## **Staff Changes**

This section covers changes proposed by Planning Staff to correct errors and to reflect changes in conversion philosophy based on discussions with the PHED Committee and the Planning Board.

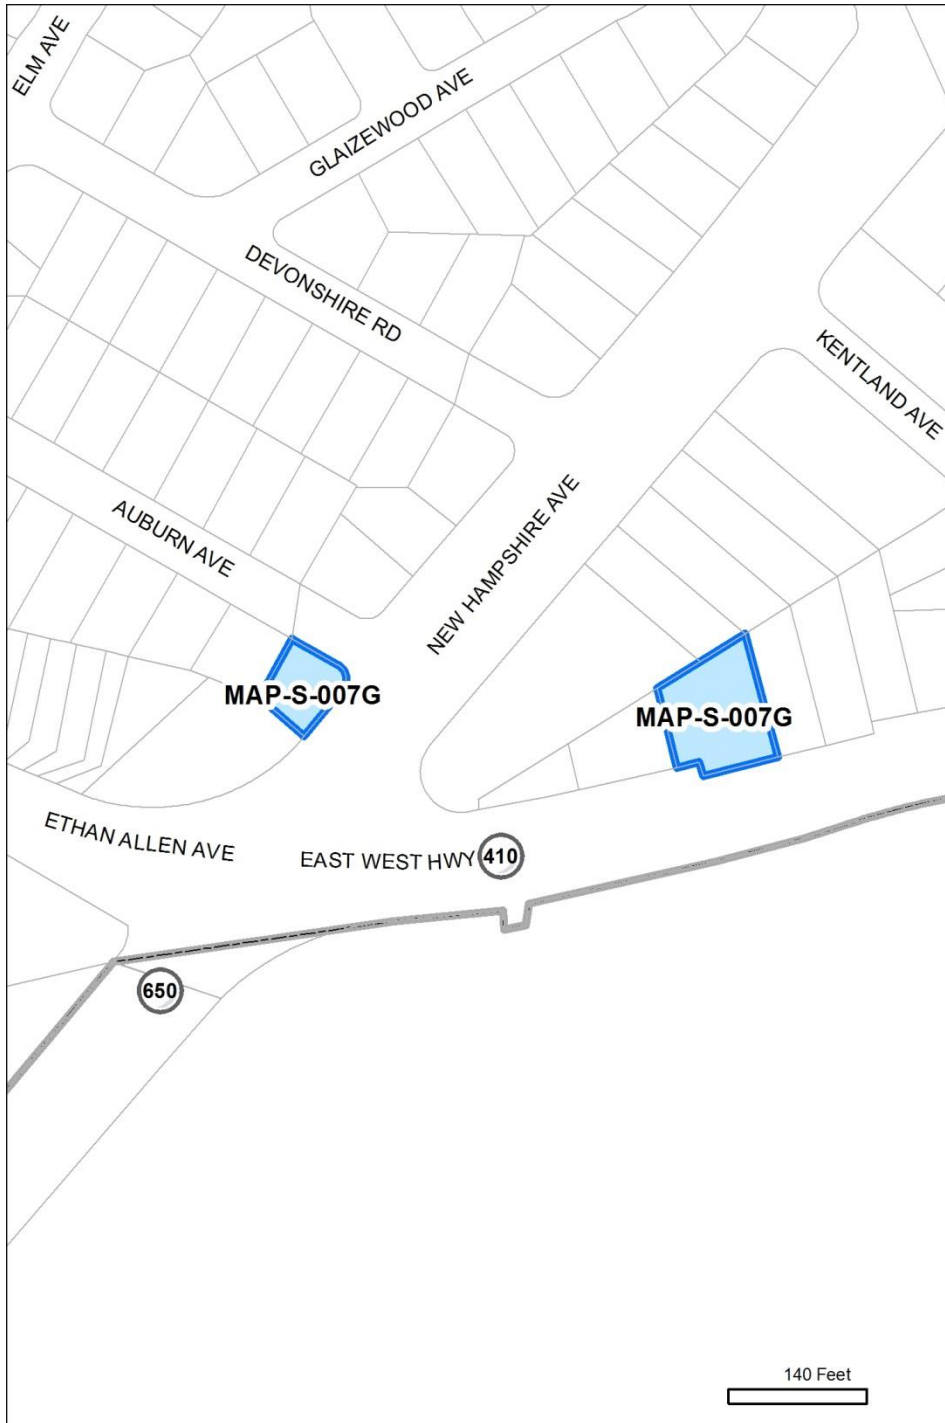
<b>Unique ID:</b> MAP-S-007G		staff rec. change
<b>Master Plan ID:</b> n/a		
<b>Master Plan:</b>	Takoma Park	
<b>Location:</b>	Near intersection of New Hampshire and East-West Hwy	
<b>Existing Zone:</b>	C-2	
<b>Proposed Conv:</b> (5/2)	<del>CRT-1.5 C-1.5 R-1.0 H-45</del>	
<b>Prop. Revised Conv:</b>	CRT-1.5 C-1.5 R-0.75 H-45	
<b>Category:</b>	Staff Recommendation	
<b>Modifications</b>	<b>Zone Group:</b>	No change
	<b>Overall FAR:</b>	No change
	<b>Comm'l FAR:</b>	No change
	<b>Resid'l FAR:</b>	Reduced to 0.75
	<b>Height:</b>	No change
<b>Reason for change:</b>		
<p><i>Since the 5/2 conversion, further staff analysis indicated that residential development in the C-2 zone is essentially limited to around 0.75 FAR. As a result, the Planning Board recommended reducing allowed residential FAR to 0.75, following its review of DMA-956. The PHED Committee agrees with this recommendation.</i></p>

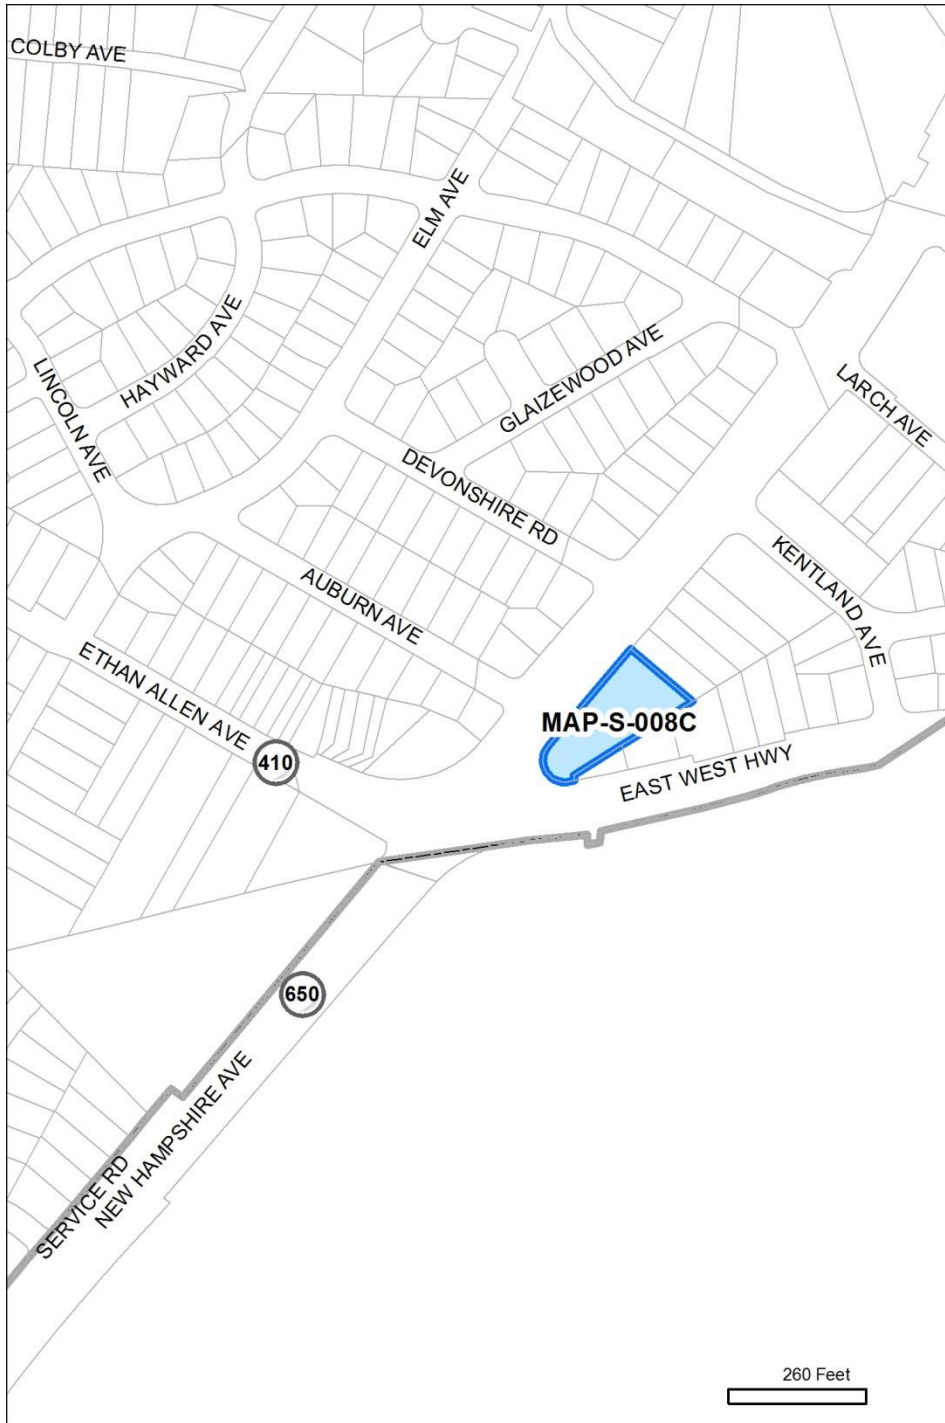
<b>Unique ID:</b> MAP-S-008C		staff rec. change
<b>Master Plan ID:</b> n/a		
<b>Master Plan:</b>	Takoma Park	
<b>Location:</b>	NE corner of New Hampshire and East-West Hwy	
<b>Existing Zone:</b>	C-2	
<b>Proposed Conv:</b> (5/2)	<del>CRT-2.0 C-1.0 R-1.5 H-45</del>	
<b>Prop. Revised Conv:</b>	CRT-2.0 C-1.5 R-0.75 H-45	
<b>Category:</b>	Staff Recommendation	
<b>Modifications</b>	<b>Zone Group:</b>	No change
	<b>Overall FAR:</b>	No change
	<b>Comm'l FAR:</b>	Increased to 1.5
	<b>Resid'l FAR:</b>	Reduced to 0.75
	<b>Height:</b>	No change
<b>Reason for change:</b>		
<p><i>Since the 5/2 conversion, further staff analysis indicated that residential development in the C-2 zone is essentially limited to around 0.75 FAR. As a result, the Planning Board recommended reducing allowed residential FAR to 0.75, following its review of DMA-956. The PHED Committee agrees with this recommendation.</i></p> <p><i>Additionally, staff recommended changing the commercial FAR to 1.5 to more accurately reflect the current allowed maximum commercial FAR.</i></p>

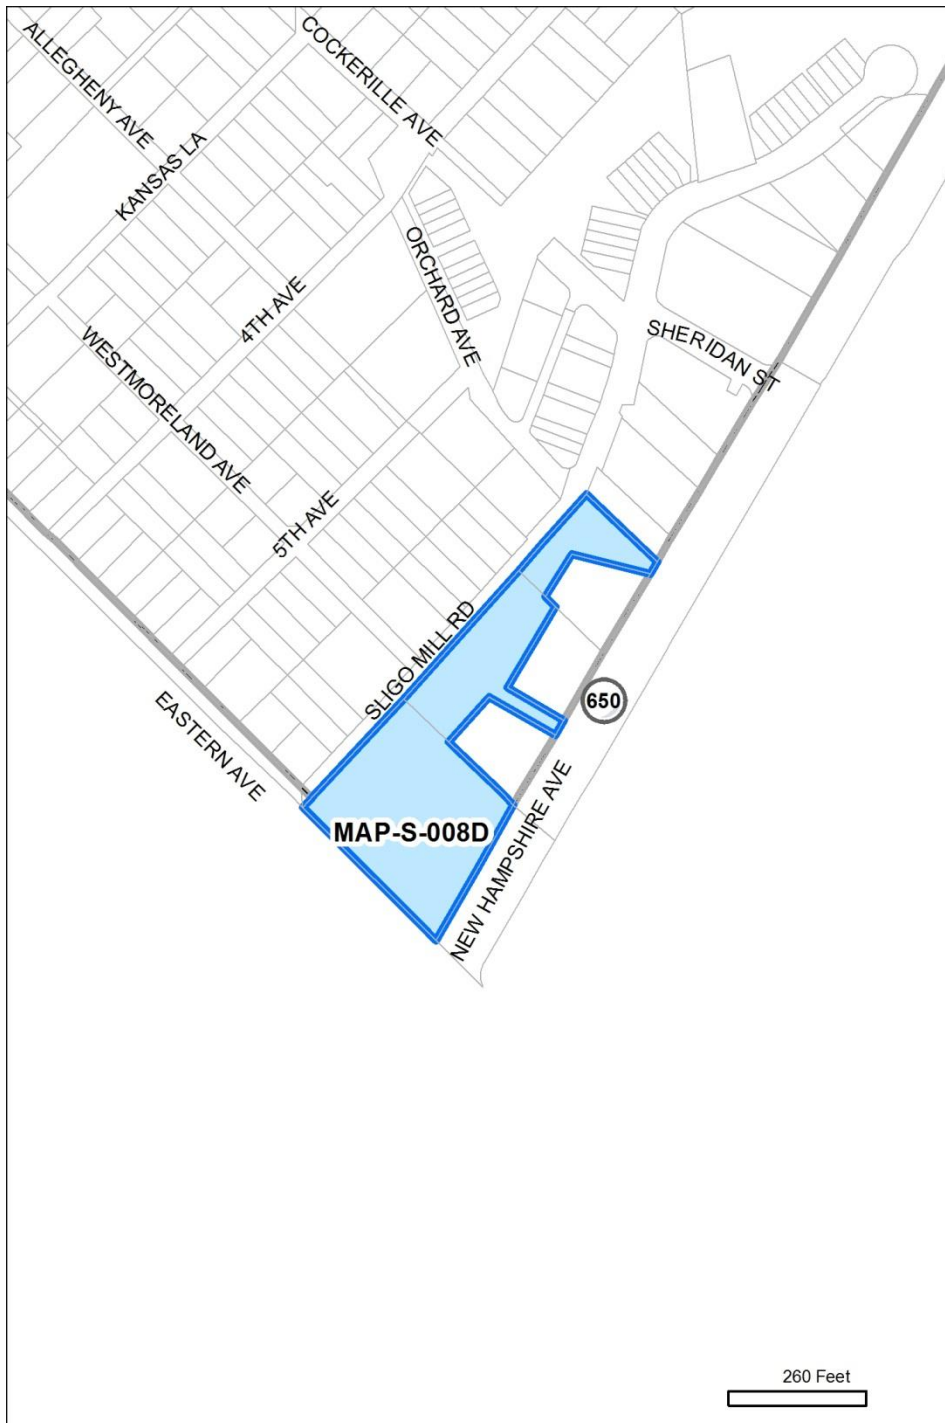
<b>Unique ID:</b> MAP-S-008D		staff rec. change
<b>Master Plan ID:</b> n/a		
<b>Master Plan:</b>	Takoma Park	
<b>Location:</b>	New Hampshire Ave north of Eastern Ave	
<b>Existing Zone:</b>	C-2	
<b>Proposed Conv:</b> (5/2)	CRT-2.0 C-1.0 R-1.5 H-45	
<b>Prop. Revised Conv:</b>	CRT-2.0 C-1.5 R-0.75 H-45	
<b>Category:</b>	Staff Recommendation	
<b>Modifications</b>	<b>Zone Group:</b>	No change
	<b>Overall FAR:</b>	No change
	<b>Comm'l FAR:</b>	Increased to 1.5
	<b>Resid'l FAR:</b>	Reduced to 0.75
	<b>Height:</b>	No change
<b>Reason for change:</b>		
<p>Since the 5/2 conversion, further staff analysis indicated that residential development in the C-2 zone is essentially limited to around 0.75 FAR. As a result, the Planning Board recommended reducing allowed residential FAR to 0.75, following its review of DMA-956. The PHED Committee agrees with this recommendation.</p> <p>Additionally, staff recommended changing the commercial FAR to 1.5 to more accurately reflect the current allowed maximum commercial FAR.</p>

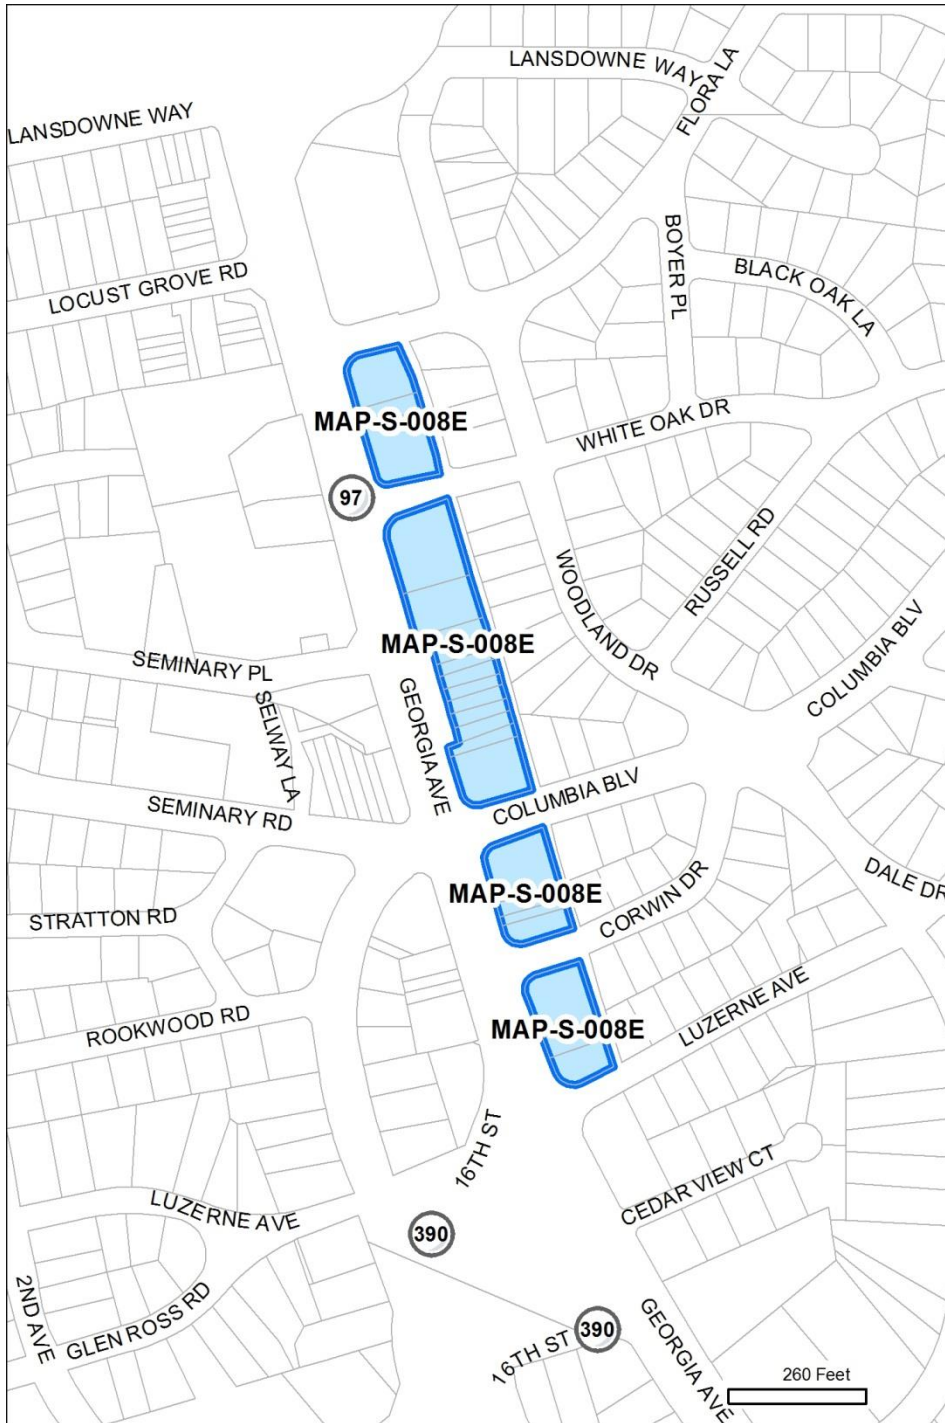
<b>Unique ID:</b> MAP-S-008E		staff rec. change
<b>Master Plan ID:</b> n/a		
<b>Master Plan:</b>	North and West Silver Spring	
<b>Location:</b>	Montgomery Hills	
<b>Existing Zone:</b>	C-2	
<b>Proposed Conv:</b> (5/2)	CRT-2.0 C-1.0 R-1.5 H-45	
<b>Prop. Revised Conv:</b>	CRT-2.0 C-1.5 R-0.75 H-45	
<b>Category:</b>	Staff Recommendation	
<b>Modifications</b>	<b>Zone Group:</b>	No change
	<b>Overall FAR:</b>	No change
	<b>Comm'l FAR:</b>	Increased to 1.5
	<b>Resid'l FAR:</b>	Reduced to 0.75
	<b>Height:</b>	No change
<b>Reason for change:</b>		
<p>Since the 5/2 conversion, further staff analysis indicated that residential development in the C-2 zone is essentially limited to around 0.75 FAR. As a result, the Planning Board recommended reducing allowed residential FAR to 0.75, following its review of DMA-956. The PHED Committee agrees with this recommendation.</p> <p>Additionally, staff recommended changing the commercial FAR to 1.5 to more accurately reflect the current allowed maximum commercial FAR.</p>

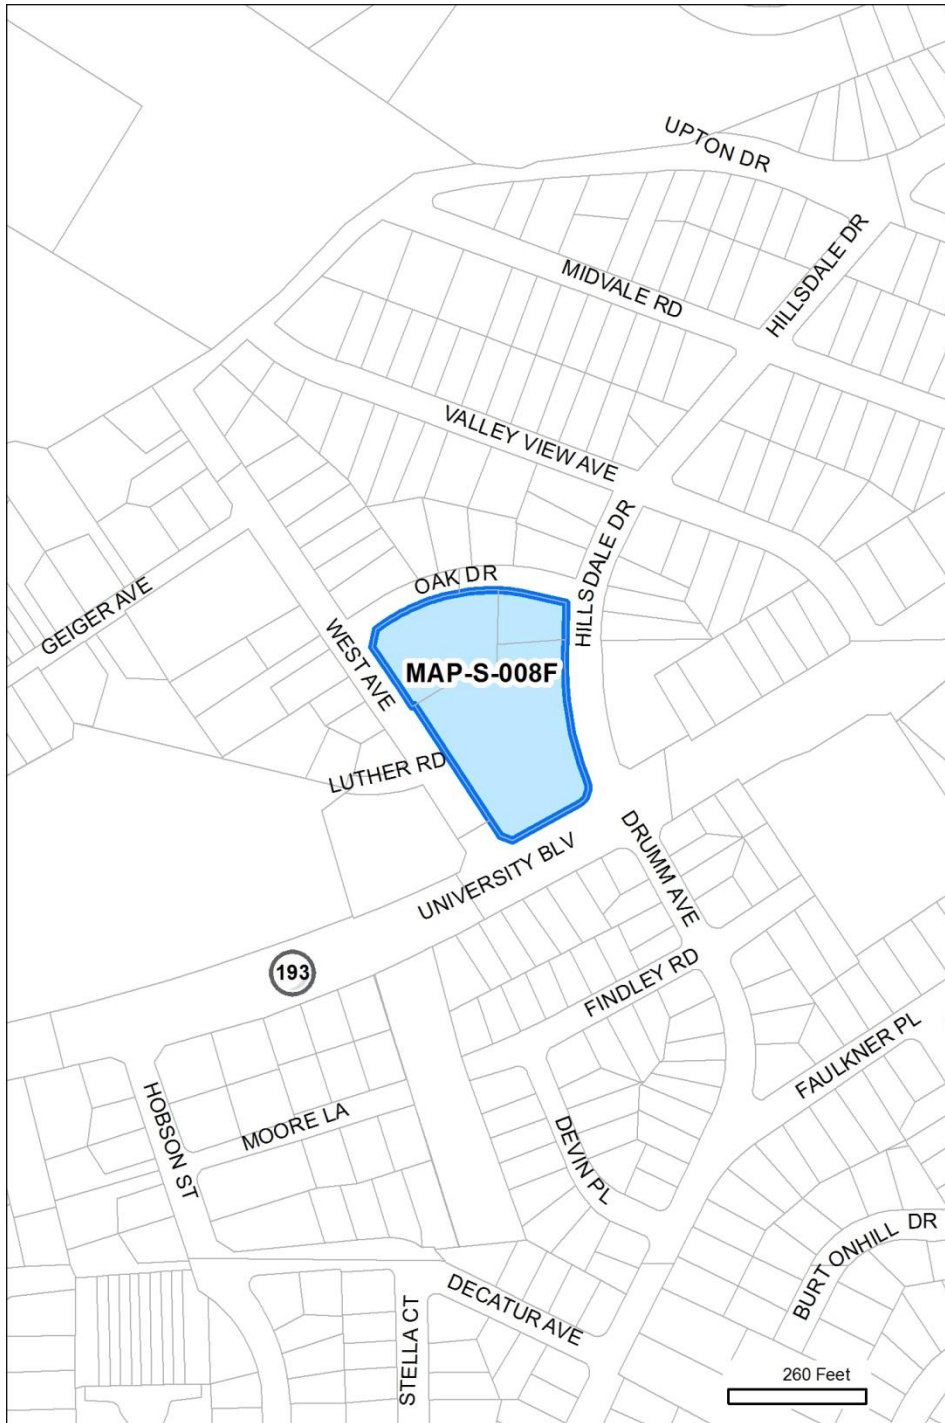
<b>Unique ID:</b> MAP-S-008F		staff rec. change
<b>Master Plan ID:</b> n/a		
<b>Master Plan:</b>	Kensington-Wheaton	
<b>Location:</b>	Surrounded by West, Oak, Hillsdale, University	
<b>Existing Zone:</b>	C-2	
<b>Proposed Conv:</b> (5/2)	CRT-2.0 C-1.0 R-1.5 H-45	
<b>Prop. Revised Conv:</b>	CRT-2.0 C-1.5 R-0.75 H-45	
<b>Category:</b>	Staff Recommendation	
<b>Modifications</b>	<b>Zone Group:</b>	No change
	<b>Overall FAR:</b>	No change
	<b>Comm'l FAR:</b>	Increased to 1.5
	<b>Resid'l FAR:</b>	Reduced to 0.75
	<b>Height:</b>	No change
<b>Reason for change:</b>		
<p><i>Since the 5/2 conversion, further staff analysis indicated that residential development in the C-2 zone is essentially limited to around 0.75 FAR. As a result, the Planning Board recommended reducing allowed residential FAR to 0.75, following its review of DMA-956. The PHED Committee agrees with this recommendation.</i></p> <p><i>Additionally, staff recommended changing the commercial FAR to 1.5 to more accurately reflect the current allowed maximum commercial FAR.</i></p>

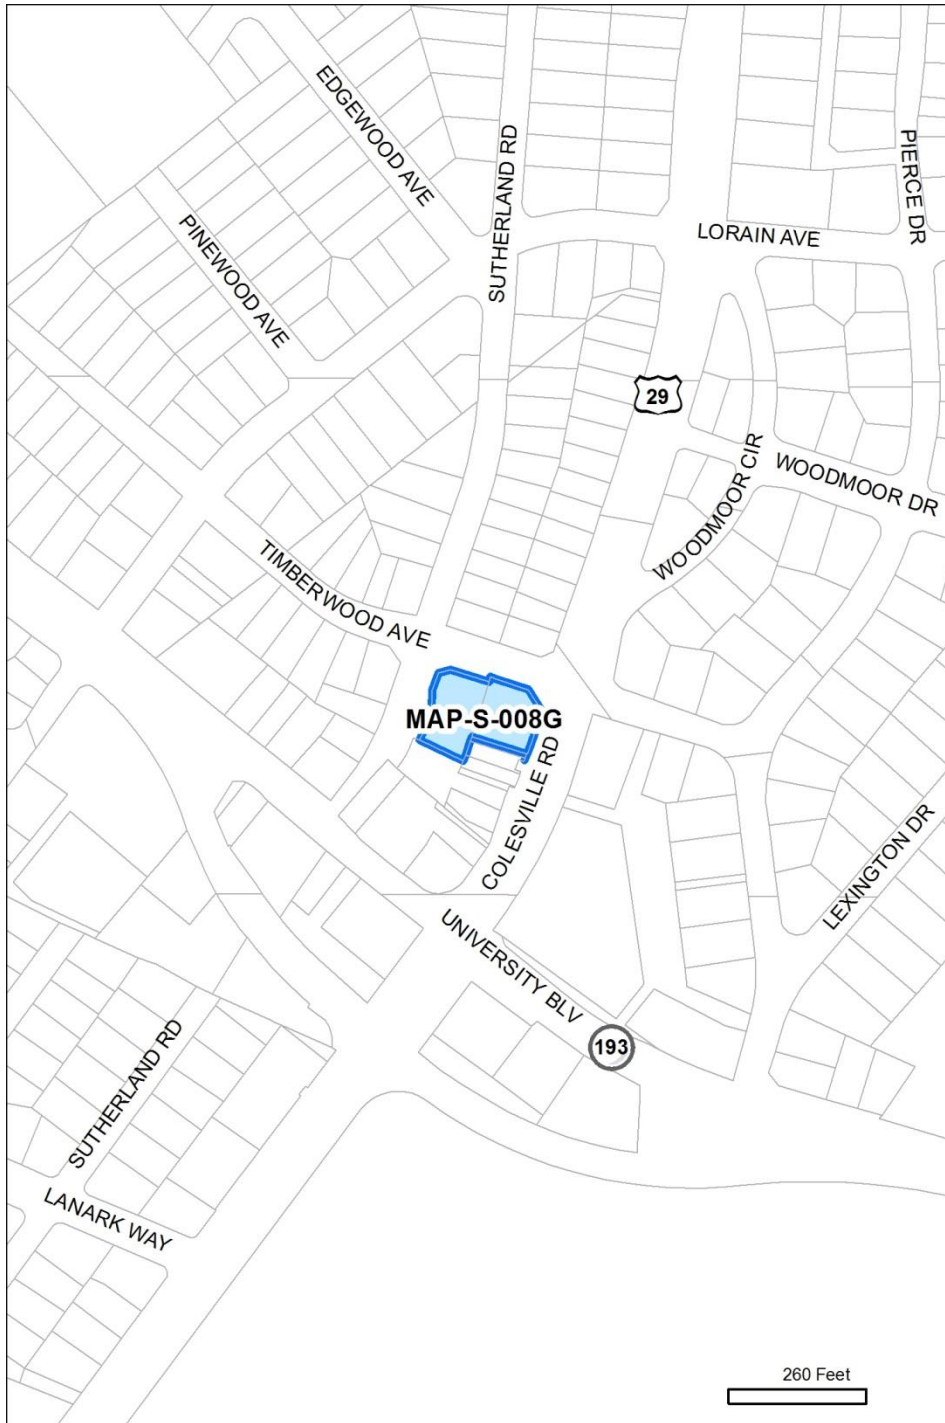
<b>Unique ID:</b> MAP-S-008G		staff rec. change
<b>Master Plan ID:</b> n/a		
<b>Master Plan:</b>	Four Corners	
<b>Location:</b>	SW corner, Colesville and Timberwood	
<b>Existing Zone:</b>	C-2	
<b>Proposed Conv:</b> (5/2)	CRT-2.0 C-1.0 R-1.5 H-45	
<b>Prop. Revised Conv:</b>	CRT-2.0 C-1.5 R-0.75 H-45	
<b>Category:</b>	Staff Recommendation	
<b>Modifications</b>	<b>Zone Group:</b>	No change
	<b>Overall FAR:</b>	No change
	<b>Comm'l FAR:</b>	Increased to 1.5
	<b>Resid'l FAR:</b>	Reduced to 0.75
	<b>Height:</b>	No change
<b>Reason for change:</b>		
<p>Since the 5/2 conversion, further staff analysis indicated that residential development in the C-2 zone is essentially limited to around 0.75 FAR. As a result, the Planning Board recommended reducing allowed residential FAR to 0.75, following its review of DMA-956. The PHED Committee agrees with this recommendation.</p> <p>Additionally, staff recommended changing the commercial FAR to 1.5 to more accurately reflect the current allowed maximum commercial FAR.</p>

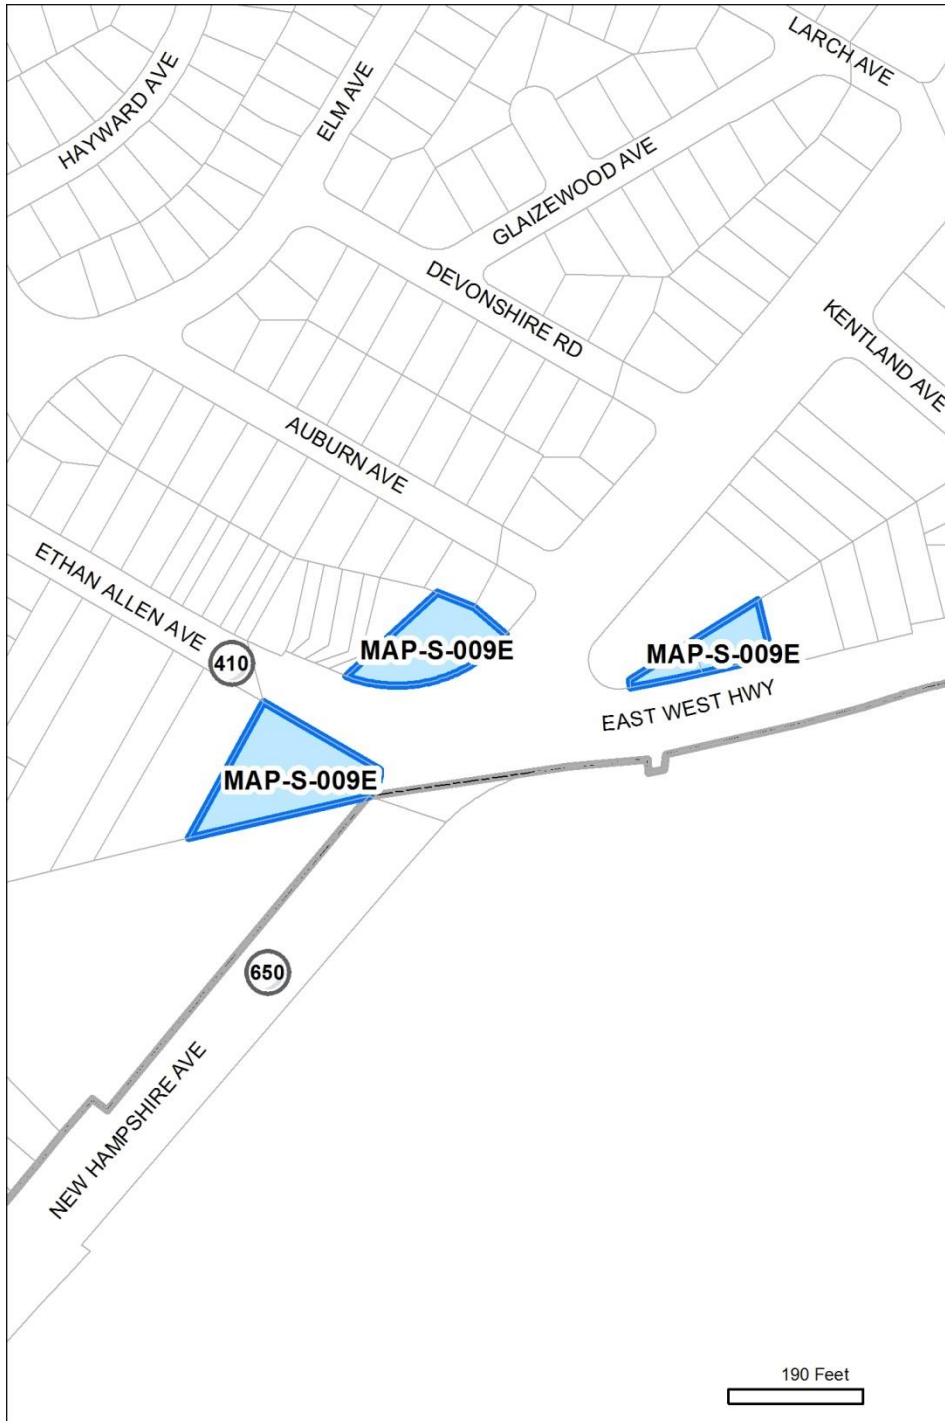
<b>Unique ID:</b> MAP-S-009E		staff rec. change
<b>Master Plan ID:</b> n/a		
<b>Master Plan:</b>	Takoma Park	
<b>Location:</b>	SW, NW, NE corners New Hampshire at East-West Hwy	
<b>Existing Zone:</b>	C-2	
<b>Proposed Conv:</b> (5/2)	CRT-2.5 C-1.5 R-1.5 H-75	
<b>Prop. Revised Conv:</b>	CRT-2.25 C-1.5 R-0.75 H-75	
<b>Category:</b>	Staff Recommendation	
<b>Modifications</b>	<b>Zone Group:</b>	No change
	<b>Overall FAR:</b>	Reduced to 2.25
	<b>Comm'l FAR:</b>	No change
	<b>Resid'l FAR:</b>	Reduced to 0.75
	<b>Height:</b>	No change
<b>Reason for change:</b>		
<p>Since the 5/2 conversion, further staff analysis indicated that residential development in the C-2 zone is essentially limited to around 0.75 FAR. As a result, the Planning Board recommended reducing allowed residential FAR to 0.75, following its review of DMA-956. The PHED Committee agrees with this recommendation.</p> <p>With the reduction in maximum residential FAR, the total FAR allowed must be reduced to 2.25 FAR.</p>
